**BROWNS FERRY NUCLEAR PLANT (BFN) - UNITS 1, 2, AND 3 - TECHNICAL SPECIFICATIONS (TS) CHANGE 409 - ADOPTION OF TS TASK FORCE (TSTF) TRAVELER - 287, REVISION 5 - CONTROL ROOM VENTILATION SYSTEM ENVELOPE - ALLOWED OUTAGE TIME**

### Technical Specifications (TS) Change 409 Adoption of TSTF-287, Revision 5 Control Room Ventilation System Envelope Allowed Outage Time

Proposed Technical Specifications Changes (mark-up)

Changes to Technical Specifications Bases Pages  
(mark-up)

3.7.3 Control Room Emergency Ventilation (CREV) System

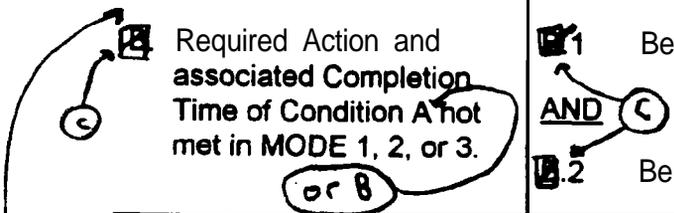
NOTE  
 The main control room boundary may be opened intermittently **under administrative control.**

B. Two CREV subsystems inoperable due to inoperable control room boundary in modes 1, 2, and 3.	B.1 Restore control room boundary to OPERABLE status.	24 hours
---	---	----------

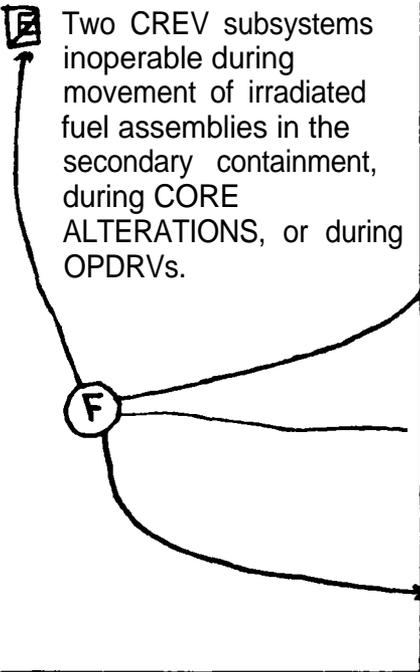
for reasons other than Condition B

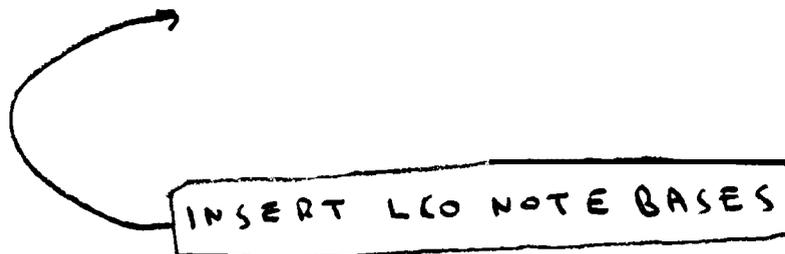
INSERT  
LCO NOTE BASES (~~BWR-4 3.7.4, MREC System~~)

The LCO is modified by a Note allowing the main control room boundary to be opened intermittently under administrative controls. For entry and exit through doors **the** administrative control of the opening is performed by **the** person(s) entering or exiting the area. For other openings, these controls consist of stationing a dedicated individual at **the** opening who is in continuous communication **with** the main control room. This individual will have a method to rapidly close the opening when a need for main control room isolation is indicated.
